EAGLE COUNTY ENGINEERING

FILE: Eagle County File No. VIS-4398

RE: Berlaimont Estates Variance to Improvement Standards Engineering Review

LOWER BERLAIMONT ROAD
STATION: 0+00 TO 15+00

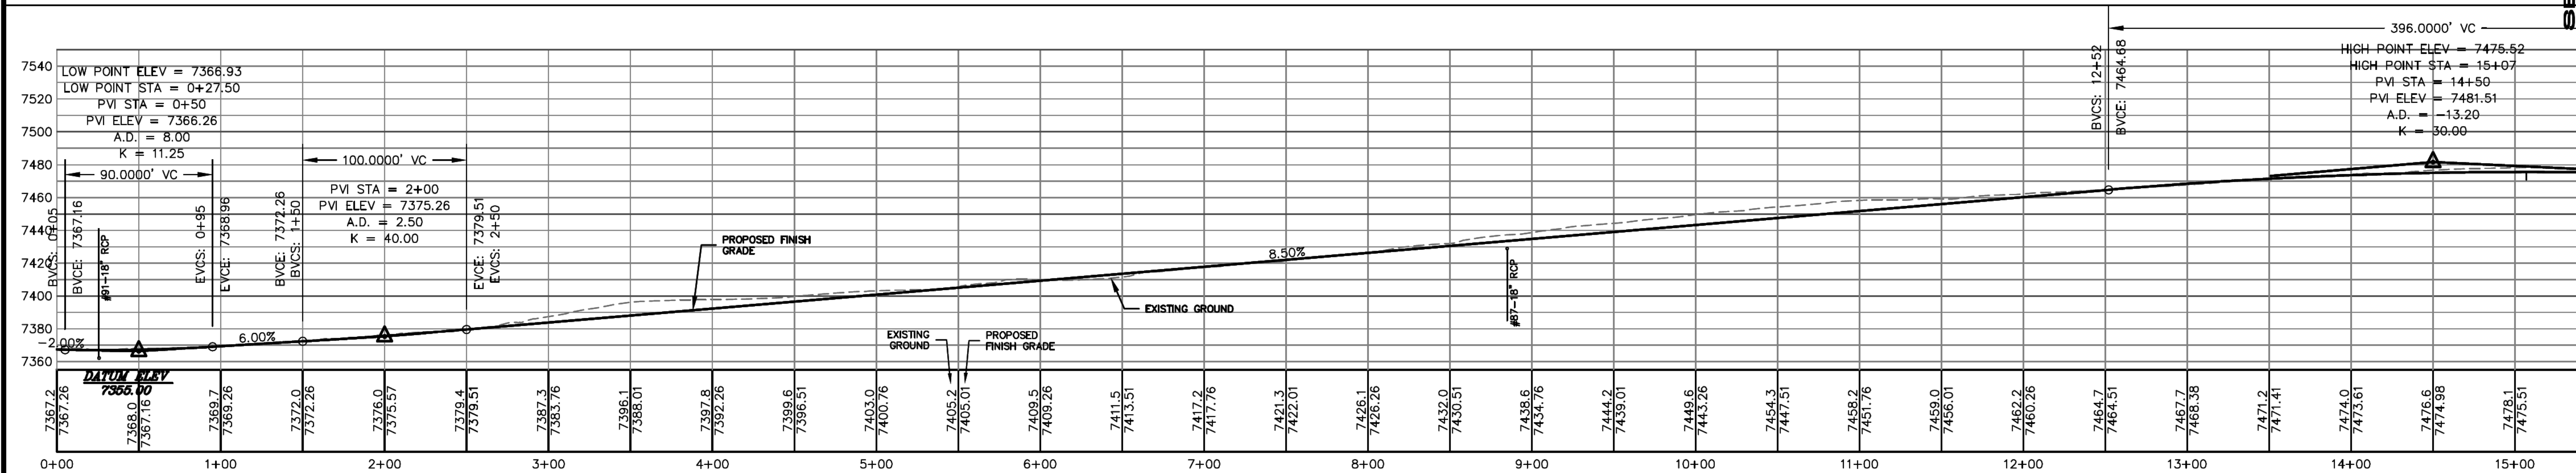
1. Please show the property line for property owned by Berry Creek Metro District in relation to the proposed improvements.
2. Eagle County Engineering will rely on the Eagle River Fire Protection District for guidance on the acceptability of the proposed Emergency Vehicle Turn-around variance request and their ability to provide service to the development.
3. This application only includes the access roadway up to a point approximately 475-ft from the property line with USFS. This variance would not apply to the road extension to the home sites. We would encourage the applicant to include the complete development road design to avoid the need for an additional Variance application.
4. Please confirm that the roadway design uses 6% maximum superelevation and AASHTO standard superelevation transitions.

The attached sheets show the property that is owned by Berry Creek Metro and the property line based on the plat for Berry Creek Ranch (also attached). No new improvements are proposed on Berry Creek Metro land.

Also, the roadway design uses 6% maximum superelevation and exceeds AASHTO standard superelevation transitions.

NO.	DATE	REVISIONS	BY
1	10/06/2011	ADDED EROSION LOGS STA 0+25-74-20 AND 9+50-14+90 AND AT 3 ENTRANCE INLETS	HM
2	09/17/2013	ADDED TRACT B PROPERTY LINE	RL
